ElectraNet SA

Response to Meritec Capital Expenditure Review

2 August 2002

Figure 1: Comparison of South Australian Summer Peak Demand Forecasts

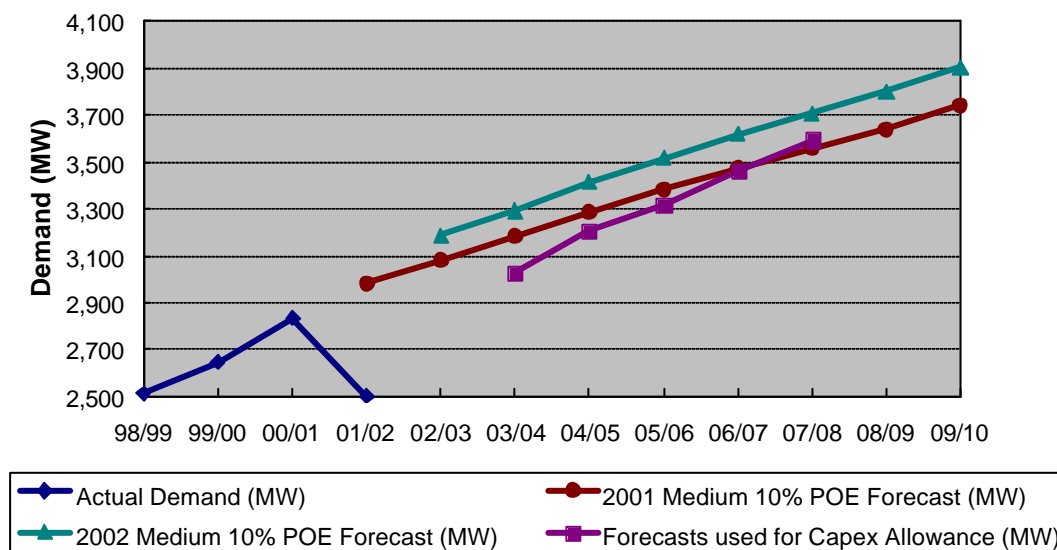
Meritec notes that ROAM Consulting assessed the relative probabilities of the low, medium and high 2001 NEMMCO forecasts occurring to be 25%, 60% and 15% respectively.

ElectraNet SA took a more conservative approach in its application using only the low and medium demand forecasts with 20% and 80% probabilities respectively. Meritec has recommended adjusting these probabilities to 25% and 75% respectively.

The Meritec recommendation has the effect of introducing even more conservatism into the customer demand forecast compared with the assessment made by ROAM Consulting.

However, recently published figures⁴ show that the current 10% probability of exceedance forecasts (for the medium growth scenario) are significantly higher than the forecasts used by ElectraNet SA in developing its proposed capex allowance (on average 190 MW higher in each year of the regulatory period). This is illustrated in the following graph.

This increase in demand forecast means that the capex allowance proposed by ElectraNet SA is even more conservative than it was at the time of ElectraNet SA's application and may in fact be inadequate to meet forecast growth in customer electricity demand during the regulatory period.

Meritec's recommendation to give additional weight to the low demand forecast scenario is inconsistent with the current increase in demand forecasts and should be rejected.
